CITY PLAN COMMISSION**THURSDAY, AUGUST 6, 2026****FILE NUMBER:** PLAT-26-000177**SENIOR PLANNER:** Sharmila Shrestha**LOCATION:** Danieldale Road, east of Cottonvalley Road**DATE FILED:** July 9, 2026**ZONING:** R-7.5(A)**CITY COUNCIL DISTRICT:** 8**SIZE OF REQUEST:** 0.4362-acres**APPLICANT/OWNER:** New Nest Properties, LLC

REQUEST: An application to replat a 0.4362-acre (18,999-square foot) tract of land containing all of Lot 15 in City Block G/7590 to create two 0.2181-acre (9,499-square foot) lots on property located on Danieldale Road, east of Cottonvalley Road.

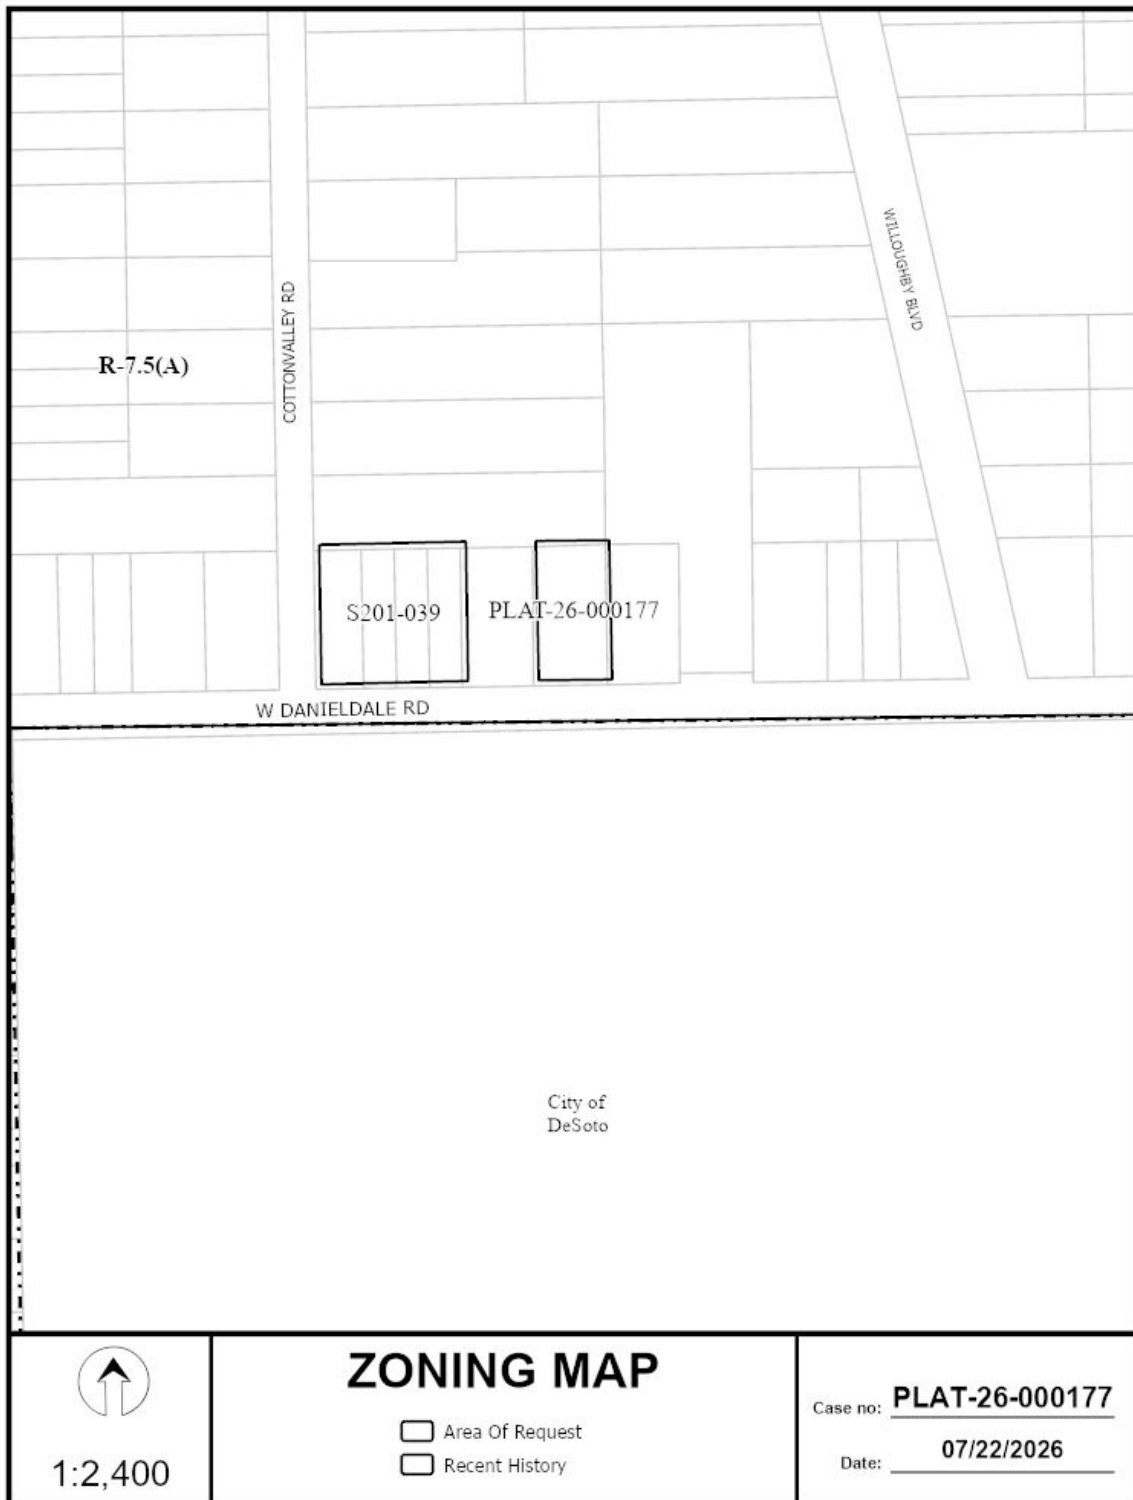
18. Prior to final plat, submit a completed final plat checklist and all supporting documents.
19. Show how all adjoining right-of-way was created.
20. Show recording information on all existing easements within 150' of property.
21. Label the jurisdictional boundary along the adjoining R-O-W. Identify the adjacent municipality and clearly depict the city limit line on the plat.
